Access Compliance Report

Public Rights-of-Way

Intersection ID: 10036441	Main Street: ROYAL_CASTLE_CT	Cross Street: N/A	Location: W
ADA ID: FF7A404DAABB	Ramp Type: BlendTrans1	Initial Pass/Fail: Fail	Overall Compliance: No
		Severity Score: 42.5	
Codes/Mitigation Info/Possible Solution		Field Measurements/Component Compliance

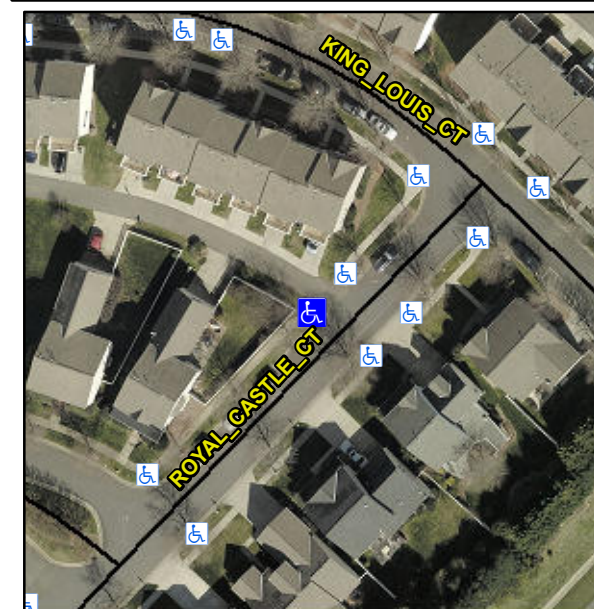
Remove & Replace Curb Ramp With Two New Directional Ramps or Equivalent.

R304.5.1, R304.5.3

Compliance	Description	Data	Compliance	Description	Data
N/A	Ramp Length (in)	92.0	Yes	BlendTrans Slope (%)	1.9
No	Ramp Width (in)	32.0	No	BlendTrans XSlope (%)	8.8
N/A	Flare Type LT	N/A	N/A	Flare Type RT	N/A
N/A	Flare Slope LT (%)	N/A	N/A	Flare Slope RT (%)	N/A
N/A	Flare Traversable LT?	N/A	N/A	Flare Traversable RT?	N/A
N/A	Landing Length (in)	N/A	N/A	DWS Provided?	N/A
N/A	Landing Width (in)	N/A	N/A	DWS Contrast?	N/A
N/A	Landing Slope (%)	N/A	N/A	DWS Length (in)	N/A
N/A	Landing X Slope (%)	N/A	N/A	DWS Full Width?	N/A
N/A	Landing Curb? (Y/N)	N/A	N/A	DWS Offset (in)	N/A
N/A	Shared Landing?	N/A			
N/A	Gutter Ponding?	N/A	N/A	Gutter Slope (%)	N/A
N/A	Gutter Lip Ht (in)	N/A	N/A	Gutter X Slope (%)	N/A
N/A	Painted X Walk1?	No	N/A	Painted X Walk2?	No
	X Walk 1 Direction	To SE		X Walk 2 Direction	To NE
	X Walk 1 Width (in)	N/A		X Walk 2 Width (in)	N/A
	X Walk 1 Slope (%)	3.5		X Walk 2 Slope (%)	4.6
	X Walk 1 X Slope (%)	4.0		X Walk 2 X Slope (%)	2.3
